**SH1 WAIKATO EXPRESSWAY
NGĀRUAWĀHIA SECTION
110 km/h ROAD SAFETY RETROFIT**
Detail Design Road Safety Audit

2 March 2022

Prepared for:
Waka Kotahi NZ Transport Agency

Figure 1: Offsets to frangible and non-frangible lighting columns

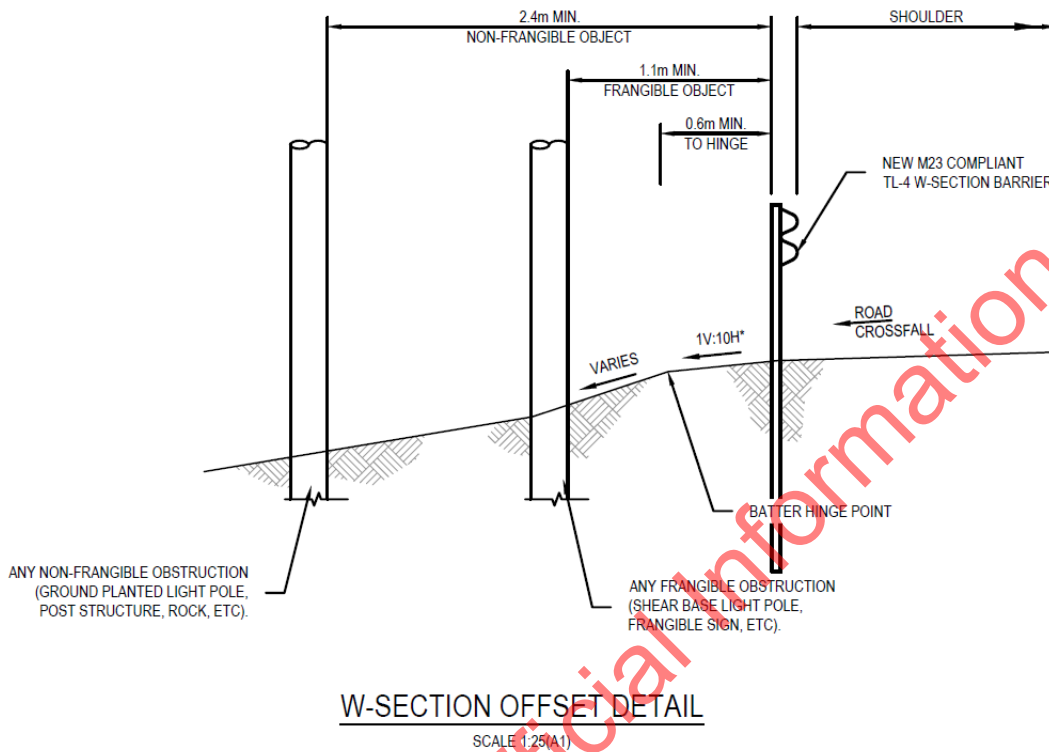
The proposed offsets to frangible and non-frangible objects are shown in Figure 1. However, the examples of a frangible and a non-frangible lighting column might be the wrong way around.

On the other hand, ground planted lighting columns are generally considered to be frangible, and do not need to be struck at any particular angle to collapse as designed.

Therefore, it is suggested that ground planted lighting columns could be placed closer to the barrier than shear base columns.

- 1 Consider allowing ground planted lighting columns to be positioned much closer to the barriers than proposed.
- 2 Where existing shear base lighting columns are to be relocated, specify ground-planted frangible lighting columns to replace the slip-base columns behind the barriers.

Figure 2: Shear base orientation to traffic

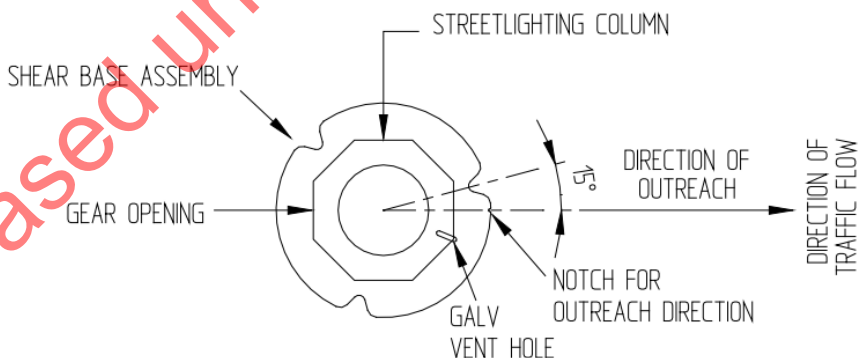
Shear base lighting columns are considered to be frangible, but they are designed to be struck directly and at high speed by a vehicle. The influence of a barrier in front of a shear base column on its performance is not currently certain. It is, however, likely that the energy required to shear the lighting column off its base would be reduced by the barrier, and that the angle of impact required for the bolts to slip off the base plate notches would differ. Note the precise 15° orientation of the notches in the base plate to the direction of traffic in Figure 2.

Figure 3: Proposed surfaced median width

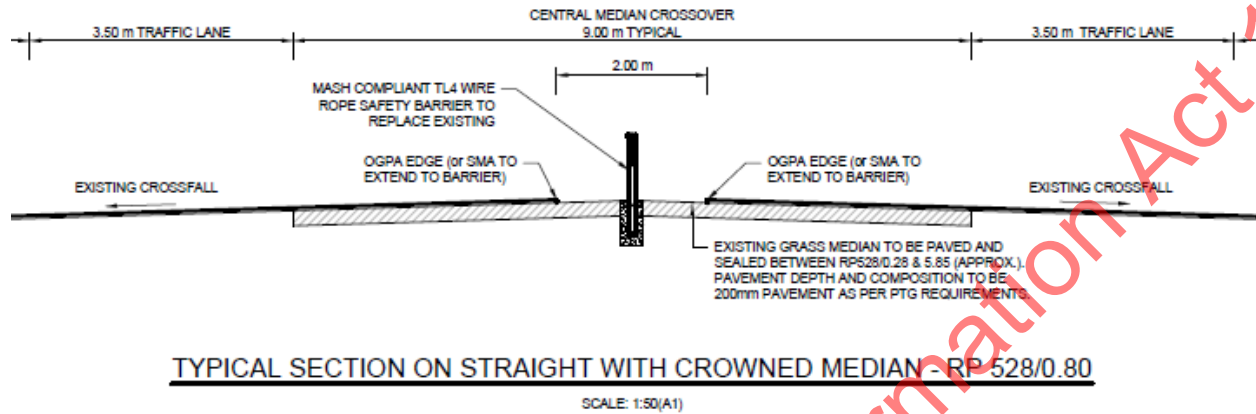
The existing median width is typically 9 m wide (edge line to edge line) as shown in Figure 3. Surfacing the median will create 4.5 m wide shoulders. The outer shoulders are being widened to 3 m as well. The surfaced width for a two-lane carriageway would thus be 14.5 m between barriers.

The width of the median shoulders seems to be excessive. Generally 3.5 m is accepted as providing sufficient sight distance past median barriers on minimum radius curves. The Ngāruawāhia section has generous curve radii.

With such wide median shoulders, there is a risk of irresponsible drivers overtaking on the shoulder and surprising motorists in the fast lane, notwithstanding the required diagonal road markings and RRPMS.

There is a considerable length of widening required to widen the existing outer shoulders by about 1.0 m to provide safe 3.0 m wide shoulders in front of the roadside barriers. Considering that the median does not need to be 9 m wide, there is a possibility that much of the widening work on the outside edge could be reduced, except for the maintenance bays.

- 1 Consider utilising some of the wide median to provide the pavement width required for the widened outside shoulders, thus eliminating the need for extended construction work along the roadside.

Figure 6: RRPMS on Longswamp to Rangiriri section (Google, 2021)

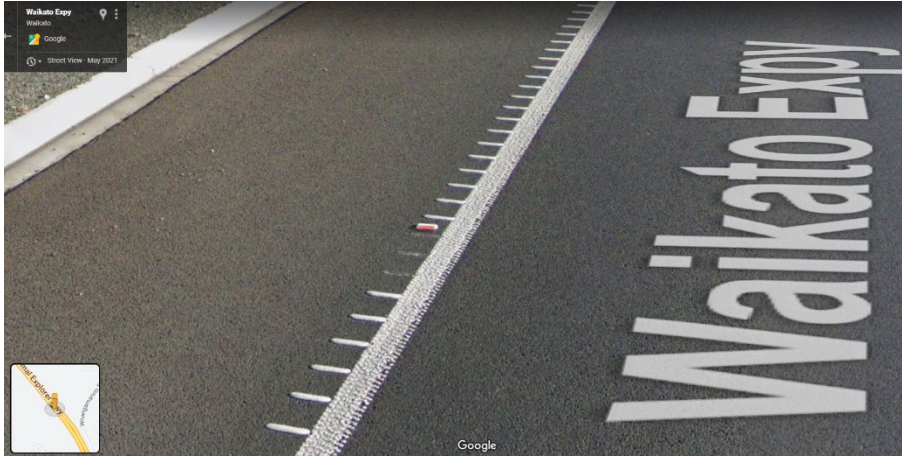
The ATP markings applied on the Longswamp to Rangiriri project (June 2020) coincided with the RRPMS. Not only did the application cover the RRPMS in many cases, but the raised portion of the ATP also tended to mask the full effectiveness of the RRPM reflectivity, effectively reducing the RRPM to about half its reflective area when viewed from the low angle of a passenger vehicle. Figure 3 shows that the ATP had to be removed ahead of each RRPM.

The RRPMS should be placed just to the left of the ATP marking.

- 1 Position the RRPMS to the left of the ATP marking.
